Access Compliance Report Public Rights-of-Way (RR Crossings)

Intersection ID: 10031407	Main Street: MCALPINE_STATION_DR	Location: N/A
ADA ID: 16D56611E1A9	Overall Compliance: No	Severity Score: 0.0
Codes/Mitigation Info/Possible Solution		Field Measurements/Component Compliance

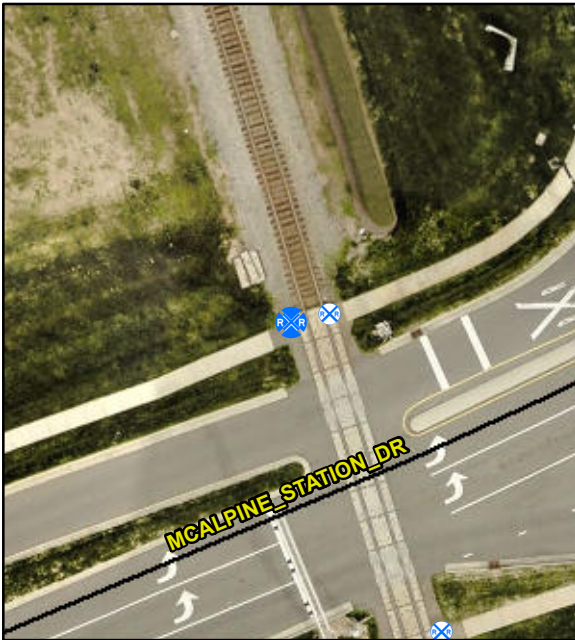
**Install Detectable Warning System.
Provide Pedestrian Gate. Remove &
Replace Walking Surface Adjacent
to Rail.**

R208.1, R302.7.4, R305.2.5

Compliance	Description	Data
No	DWS Provided?	No
N/A	DWS Contrast?	No
N/A	DWS Width (in)	No
N/A	DWS Length (in)	N/A
N/A	DWS Offset (in)	N/A
No	Pedestrian Gate?	No
N/A	DWS Outside Gate?	No
N/A	Rail Type?	Freight
No	Flangeway Gap (in)	3.0
Yes	Sidewalk Width (in)	59.0
